MIDI ALUMINIUM FABRICATOR LTD.

工程指示 / 要求簡箋 ENGINEER INSTRUCTIONS(E.I.)

工程指示編號:	EI- 7708	修改版本:	-
	HK- 0774		
工程編號:	J 856	工程名稱:	天榮站
收件人:	生統/Maggie/林哥	發件人:	Iris
工程項目:	T2-T3旭格趟門框EPDM膠條(大貨)	日期:	03/05/2024

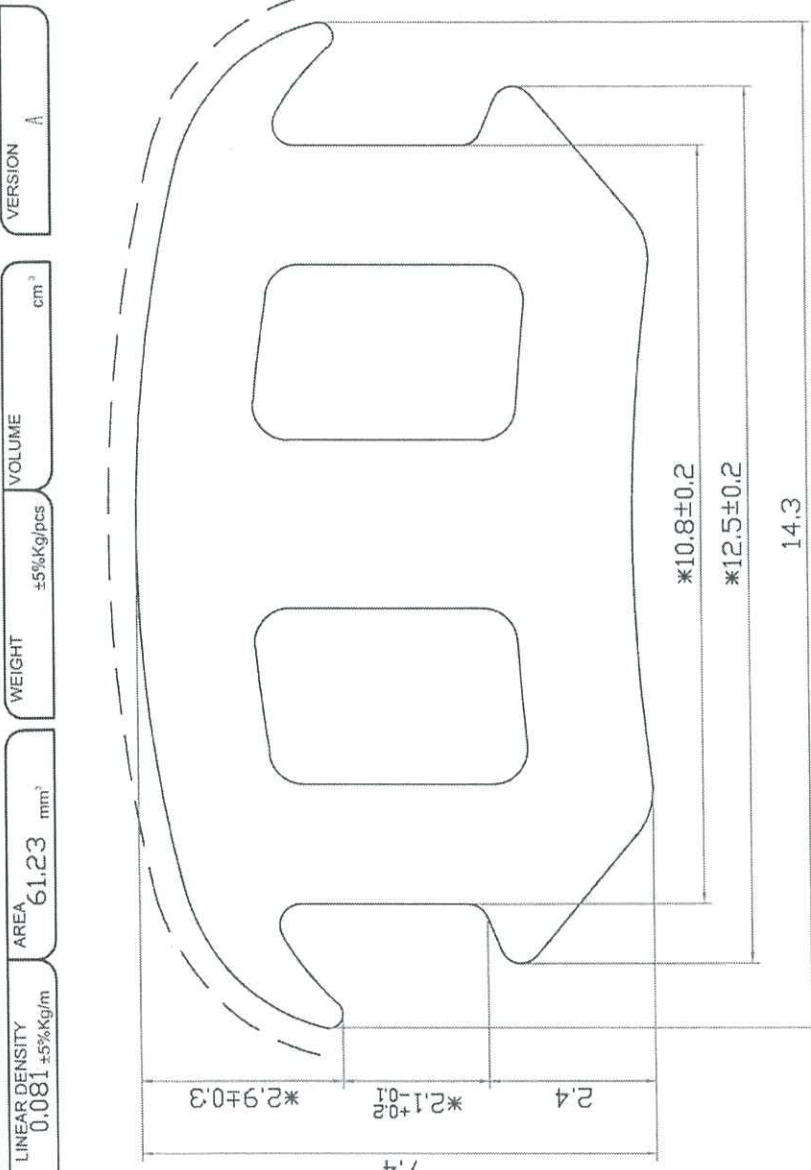
內容: T2-T3旭格趟門框EPDM膠條(大貨)
經地盤T2 12/F B8測試及按2/5/2024與怡輝會議結論, 確認使用此款膠條作為替代旭格膠條之用。建議訂購20000直米(17875米實用+10%備用) 完成後送地盤
地盤聯絡人: 阿倫:9276 7955 / 婷姐:5104 9668
完成上列要求日期: 10/05/2024
